Video Products Technical Bulletin 30-2003-134

DATE: July 7, 2003 SUBJECT: PARTS REGISTRATION—NEW A BOARDS COMPLY WITH EMC REGULATIONS

MODEL: PVM-14N5E

Figure 1

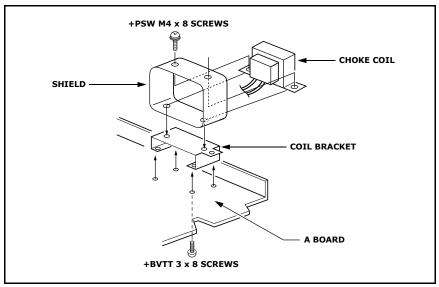
- 1. Remove L601 and install CN610 in its place.
- 2. Install a new choke coil as shown in Figure 1.

Figure 2

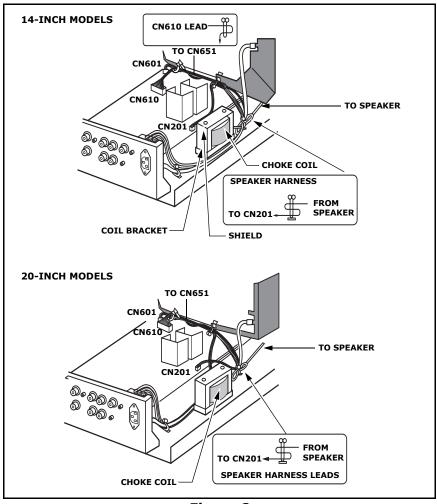
3. Route leads as shown in Figure 2.

Figure 3

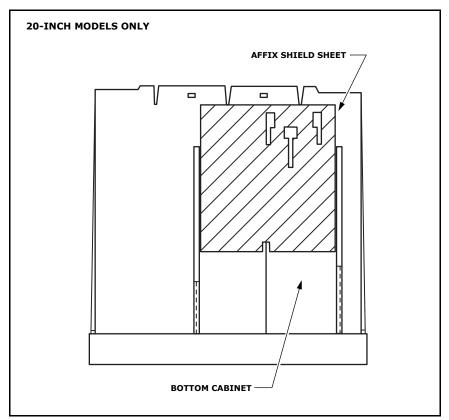
4. For 20-inch models only, affix a shield sheet to the bottom cabinet as shown in Figure 3.
